APPLICATION NO.	FILING DATE	FIRST NAMED INVENTOR	ATTORNEY DOCKET NO.	CONFIRMATION NO.
10/681,832	10/08/2003	Ralph A. Graf	LZ-79	6604
7590 10/29/2004			EXAMINER	
Friedrich Kueffner Suite 910 317 Madison Avenue New York, NY 10017			WELCH, GARY L	
			ART UNIT	PAPER NUMBER
			3765

Office Action Summary

10/681,832

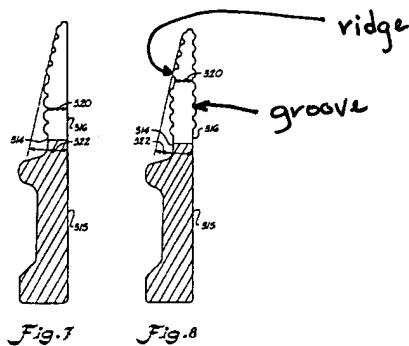
Hollingsworth et al. a sawtooth wire for producing all-steel sawtooth clothing for a doffer and/or a doffing cylinder of a carding machine, the sawtooth wire comprising a plurality of teeth 315 successively arranged in a longitudinal direction of the wire, each tooth having a tooth breast beginning at a tooth bottom and extending in a direction toward a tooth tip (Figures 7 and 8), and a tooth back that is connected with the tooth breast by two tooth flanks extending parallel to the longitudinal direction of the wire and extends from the tooth tip in a

direction of a tooth bottom of a following tooth, at least one of the tooth flanks having at least one profile segment located between the tooth tip and the tooth bottom and provided with profiling (see figures below).

With regard to claim 2, the profile segment has at least one of at least one profile ridge and at least one profile groove (see figures above).

With regard to claim 10, a flat transition segment is located between at least two adjacent profile ridges or grooves of the profile segment (see figure above).
